**City of Kingston  
Report to Planning Committee  
Report Number PC-25-009**

**To:** Chair and Members of the Planning Committee  
**From:** Paige Agnew, Commissioner, Growth & Development  
**Resource Staff:** Tim Park, Director, Planning Services  
**Date of Meeting:** March 20, 2025  
**Subject:** Recommendation Report  
**File Number:** D35-003-2021 & D09-003-2021  
**Address:** 5 Lower Union Street  
**District:** District 10 – Sydenham  
**Application Type:** Official Plan, Community Improvement Plan & Zoning By-Law  
Amendment  
**Owner:** Friend of the Marine Museum  
**Applicant:** Homestead Land Holdings Ltd.

The application proposes to amend the Official Plan and the zoning by-law (File Number D35-003-2021) in order to permit development of the property with a 19-storey mixed-use building. The current building design is a result of iterative re-design process completed in consultation with staff, peer reviewers, and technical groups. The podium configuration has been revised to provide 1-storey of below-grade parking, accessed from the parking area associated with the adjacent Shipyards apartment property. Above the below-grade parking area, the building displays a 3-

Figure 3 Possible configuration of mooring and breasting dolphins

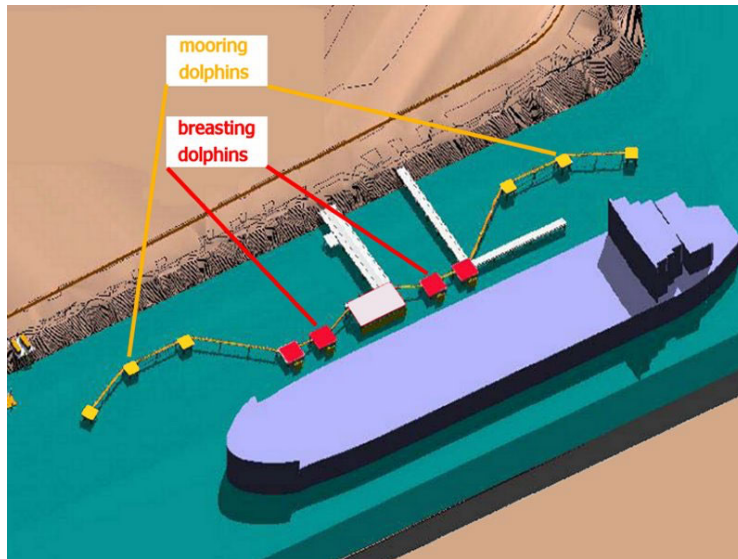
If the initial Waterfront path construction at the end of the 5 Lower Unit wharf is does not have the required structural strength for the later installation of breasting bollards, then a set of breasting docking dolphins will be needed as well as such the mooring dolphins. An example is shown schematically in Figure 3.

Figure 4 – Bus Parking in Turn-around Circle

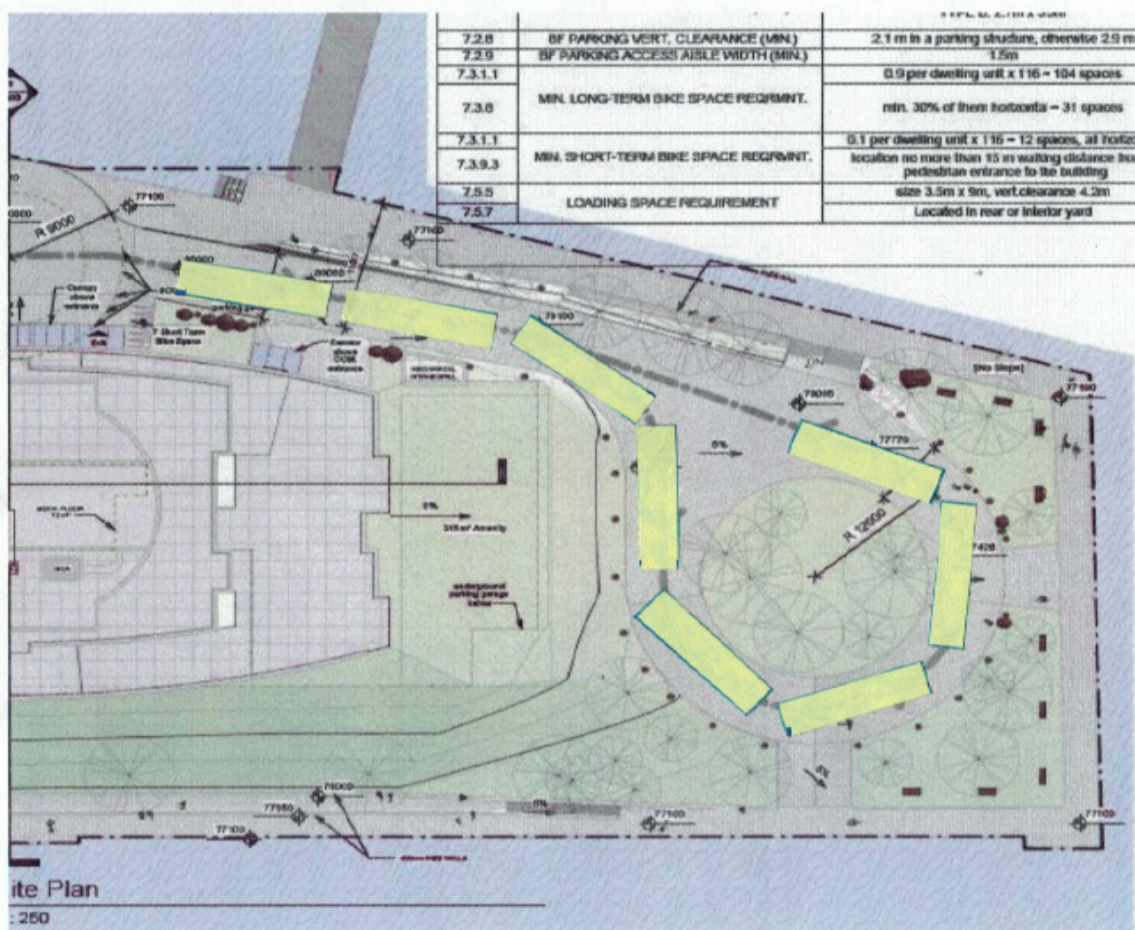
The dimensions of the Scania K114EBX2 bus are used as being typical of a 50-seat bus .The dimensions are listed in Table 2 and used in Figure 4. These buses are shown as yellow rectangles and are dimensioned to the same scale as the drawing. Figure 4 shows the worst-case scenario of the location of the buses to transport the 400 passengers disembarking to be taken to a scheduled event or events. Sufficient school buses (8) of 50 seat capacity are shown in the turnaround circle. They block the turn-around circle and could block the entrance traffic circle to the building garage with a long tail-back. Even a single bus could block the turn-around circle to other traffic and cause prolonged disruption to traffic and parking.

Furthermore, the ship turnaround circle is also the fire emergency access. This situation is not compatible with the need for immediate and urgent access by ambulances or fire tenders.

The requirement for the turn-around circle for the busses for the transport of the cruise ship passengers necessitates reducing the width of the Waterfront path. It is reduced from the required 10m to approximately 3m. Yet as seen in Figure 4 and explained in Section 5 above, this turnaround circle is inadequate for a 400-passenger ship and even more so for a ship with 500 passengers.

original drawing by Alexander Wilson Architect Inc.

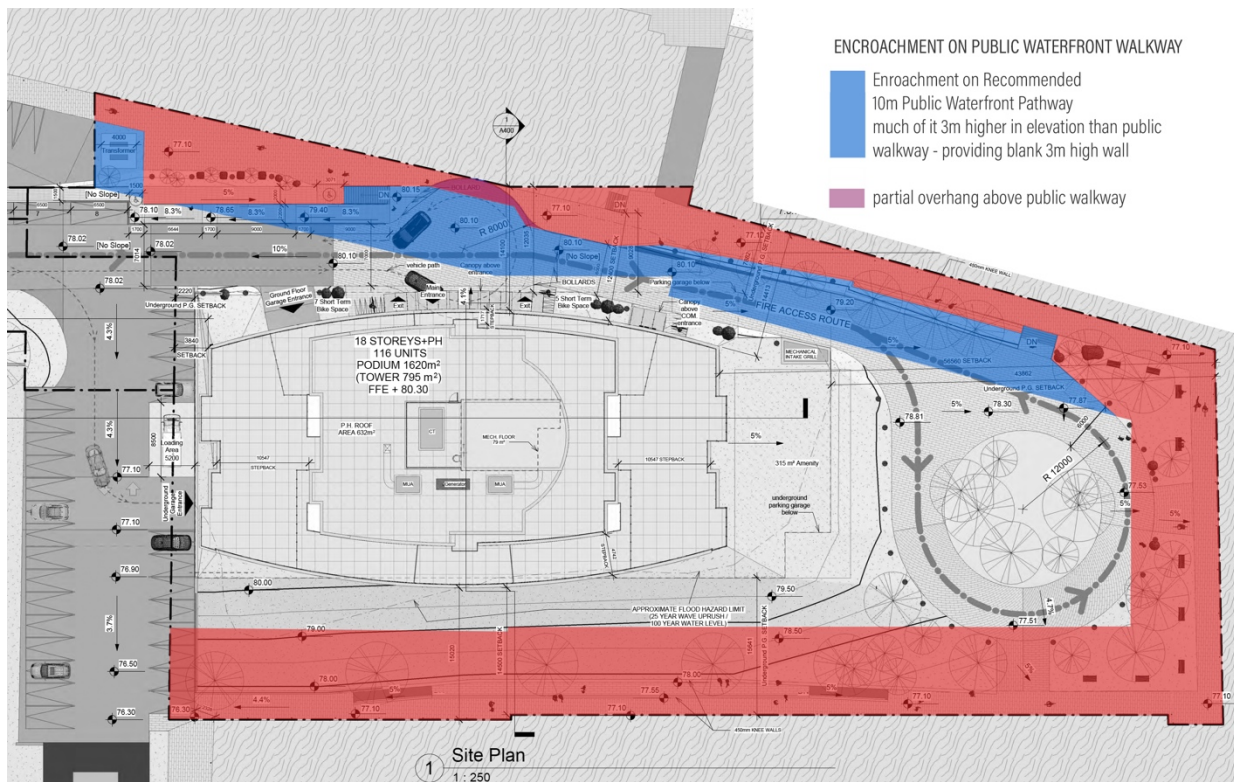
The drawing below is highlighted to illustrate the required 10m public zone (red + blue). It also illustrates the extent to which the current design proposal imposes upon that essential public space (blue). Most of this impact results from the proposed single storey structure created to provide vehicle access to a level one full storey above current grade, and above the proposed public walkway grade (more on the impact of this below under the heading View Corridor Encroachment). Also impactful is the retaining wall structures required to bring the large vehicle turning circle back down to adjacent grades. A pad-mounted transformer is also proposed to be within this Public Waterfront Walkway.

original drawing by Alexander Wilson Architect Inc.

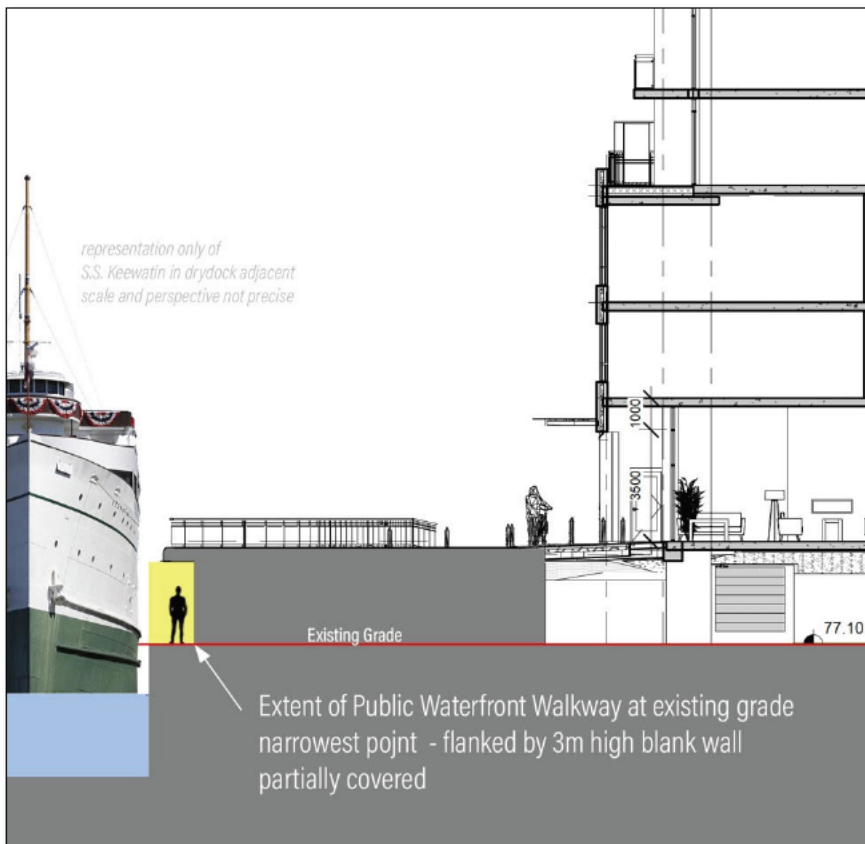
The most egregious imposition on the public walkway is proposed adjacent to the elevated drive lane/turning circle where the path is reduced in width to approximately two metres (not dimensioned). This restricted path is flanked by a blank wall nearly 3m high and partially covered by a cantilevered structure above it which would support the vehicle turning circle. This entirely inappropriate public space is made more cavernous by the adjacent Keewatin Cruise ship which is not illustrated on the drawings. The drawings also do not illustrate any detail regarding the walls of the drydock or the bollards with which the ship is moored. There may be conflicts to further reduce the available public walkway which are not yet apparent.

33. View analysis showing the protected view down Lower Union Street, to Lake Ontario, from Wellington Street, with the proposed tower (Source: Alexander Wilson Architect Inc, 2023).

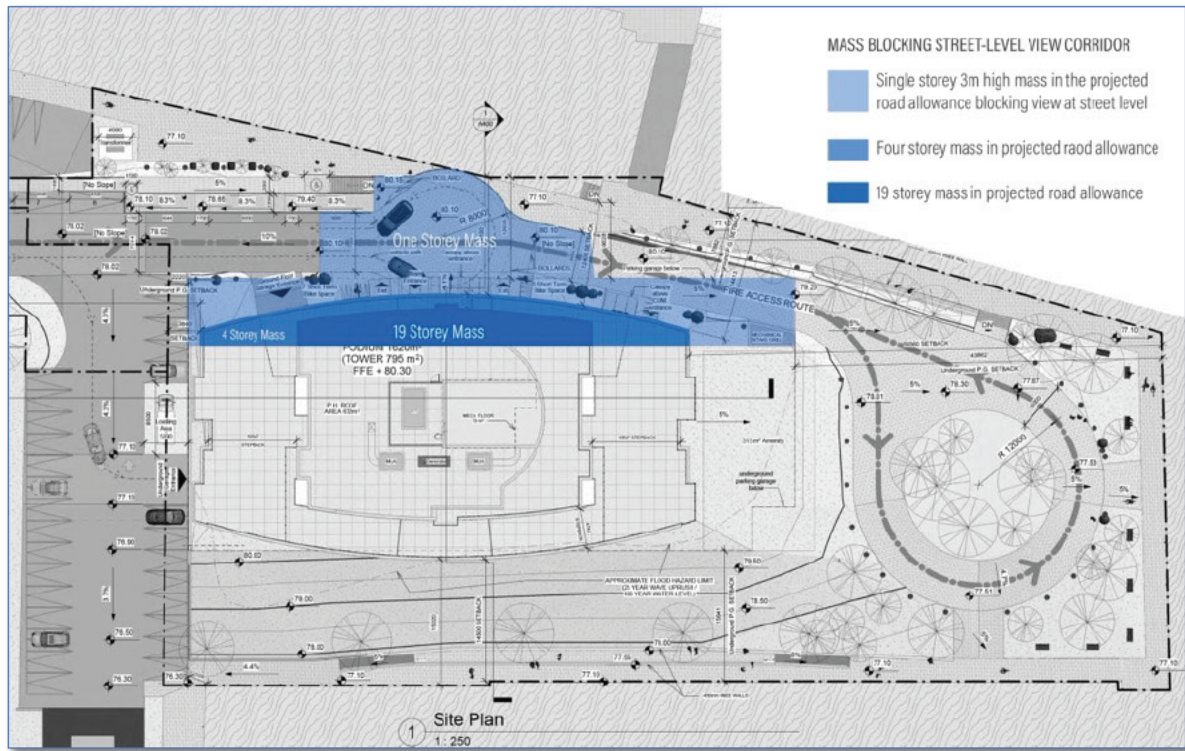
The following image is copied from the Urban Design Study and Conceptual Site Plan, March 1, 2023, by ERA Architects Inc. I believe that this image does not fully reflect the current design.

Proposed north elevation (Alexander Wilson Architects, 2023).

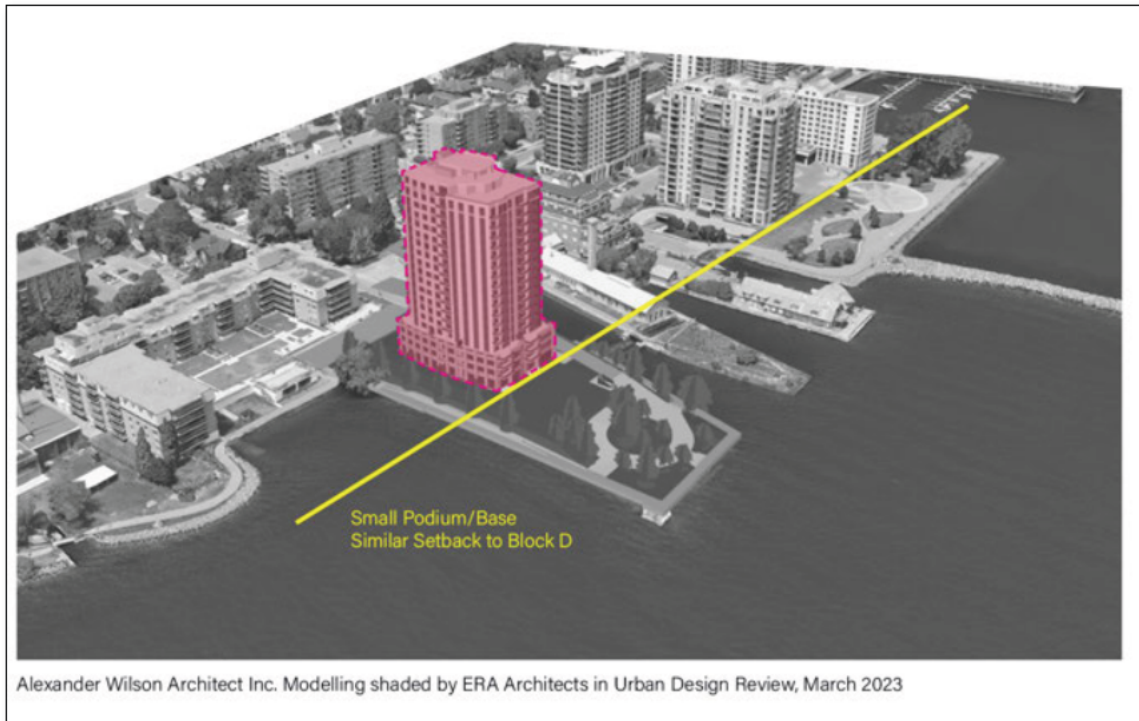
A pedestrian following the waterfront trail through Navy Park would be confronted by a long 4-storey high, imposing wall, with tower above. It is this pedestrian experience and the integration of the built form with the public realm which should be the focus of this design and not the abstract application of urban street design principles which are not suited to this location.

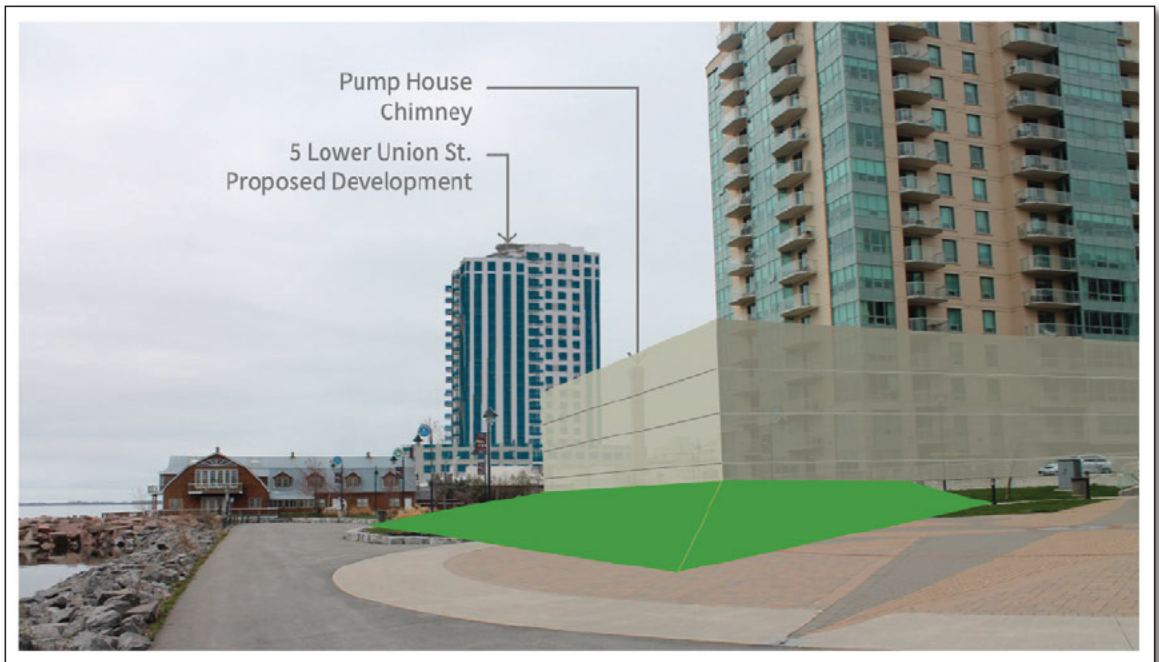
This image below from the latest ERA Architects' report shows the impact of the enlarged 4 storey mass, in contrast to the simple tower structure which is the Royal George Condominium on Block D.

The base of the proposed building would form a complete backdrop to the smaller scale heritage buildings on the waterfront trail. Let's imagine that the Royal George Condominium had adopted a similar form to that proposed for this new development as approximated below. This would be significantly more visually imposing than the building which exists, if it were just more private condos. It illustrates the inappropriateness of the proposed form, in this location. Imagine the impact if this design principle had been applied to all four buildings on Block D.

Figure 1: The maximum floor plate size of 750 sq m includes all built areas, such as dwelling units, offices, indoor amenity facilities, elevator cores, storage spaces, stairwells, hallways, etc., but excludes inset or projecting balconies.

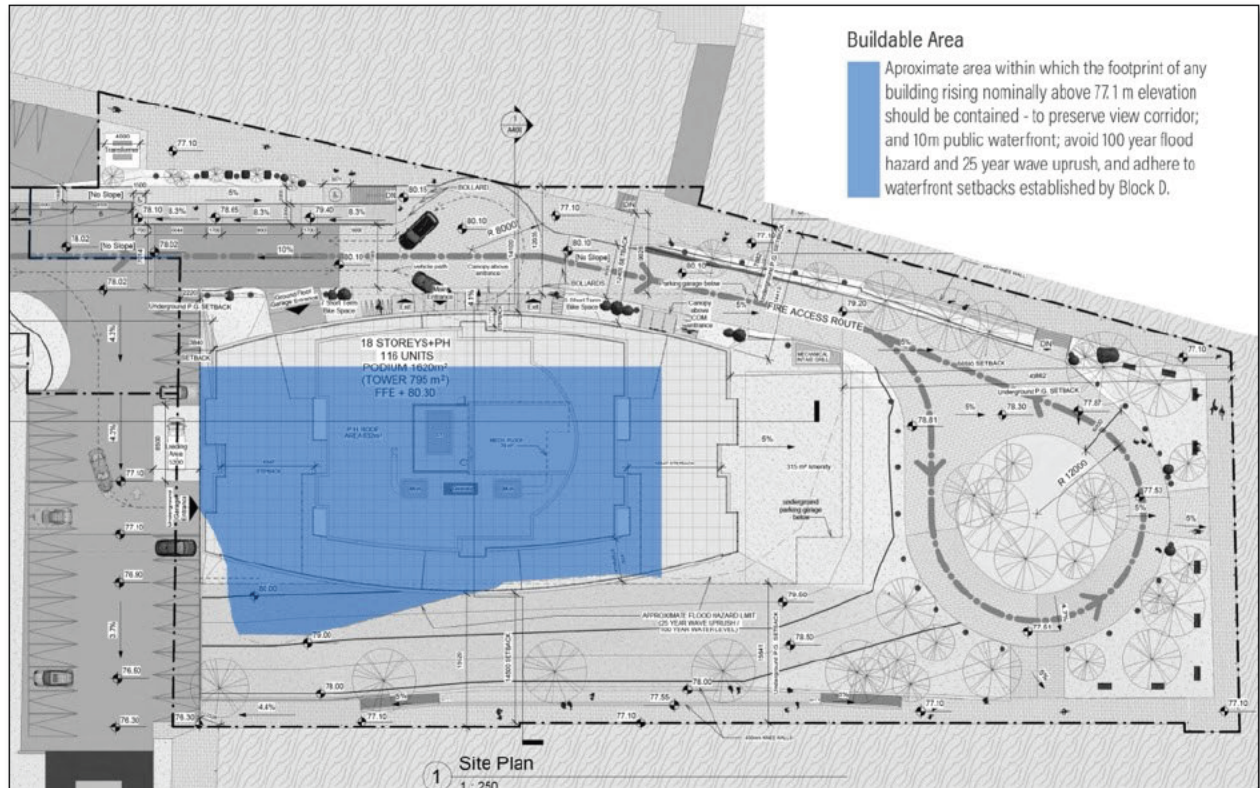
The City of Kingston “Density by Design: Kingston Mid-Rise and Tall Building Policy - Issues and Options Report” page 28, recommended a maximum 700m<sup>2</sup> floor plate for waterfront buildings. The current design is 795m<sup>2</sup>.

1. a footprint within the buildable area defined by the figure above, respectful of view corridor, public walkway space, environmental hazards and precedent set-backs (Block D),
2. a tower with a floor plate of 700m<sup>2</sup> or less,
3. a building height less than 17 stories,
4. a “shallow” rather than “deep” floor plate design,
5. a building design which minimizes impact on vistas over the water,
6. base level finishes, textures and quality of materials which reflect the heritage architecture in the vicinity of the project, and
7. excellence in architecture and landscape design which better integrates the building form with the public realm.
